Work Order ID 101701

Item Name: Crosstube Fwd High

DART AEROSPACE LTD	Work Order:	101701
Description: Crosstube High Fwd (205/212/412)	Part Number:	D212-664-101
Inspection Dwg: D212-664-141 Rev: D		Page 1 of 1

DRAWING NO. D212-664-141	TITLE XTUBE ASSY (205/212/412 HI FWD)	REV. D	DART AEROSPACE LTD ENGINEERING ORDER		D.E.O. NO. D212-664-141-D-1	SHEET NO. SHEET 1 OF 2	SCALE NTS
DRAWN	CHECKED	MFG. APPR.	APPROVED	DE APPR.			
DATE 11.04.07	DATE 11.04.11	DATE 11.04.12	DATE 11/04/12	DATE 11.04.12

**D212-664-141/-141B
ASSEMBLY DETAIL**

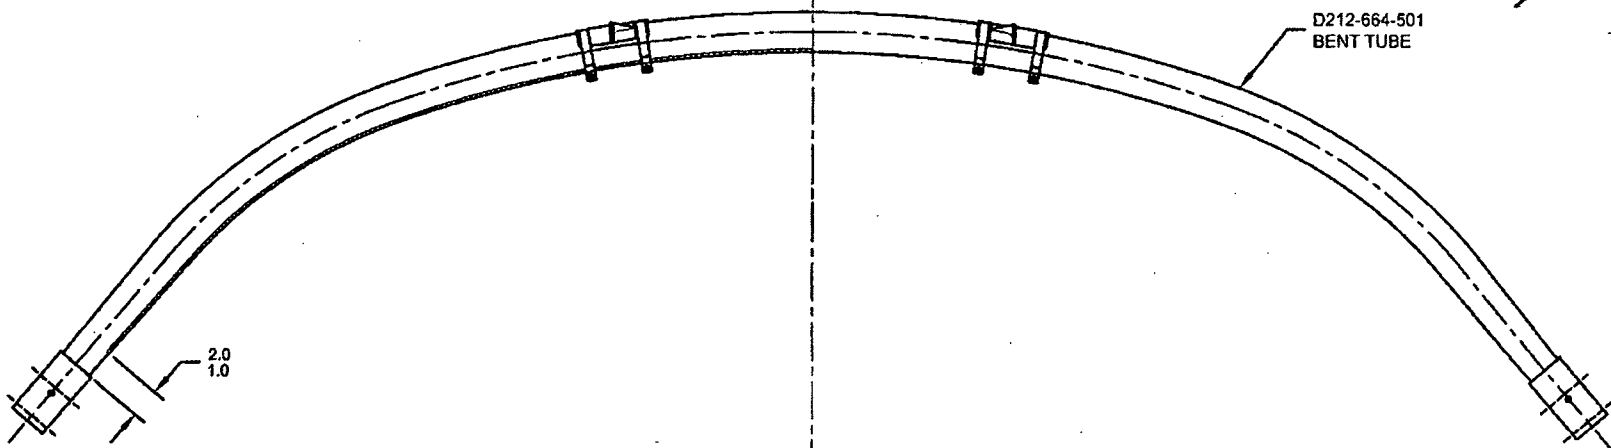
PURPOSE:

ADD AN INSPECTION WINDOW TO UNDERSIDE OF CROSSTUBE.

NOTES 2 OF SHEET 1 IS AMENDED AS FOLLOWS:

- 2) FINISH: CHEMICAL CONVERSION COAT PER DART QSI 005 4.1
PRIME INSIDE AND OUTSIDE PER DART QSI 005 4.2
MASK UNDERSIDE OF CROSSTUBE AS SHOWN (HATCHED AREA) AND
PAINT OUTSIDE PER DART QSI 005 4.2
REMOVE MASKING AND APPLY CLEAR COAT

MASK AREA PRIOR TO PAINTING.
REMOVE MASKING AFTER PAINT
AND APPLY CLEAR COAT
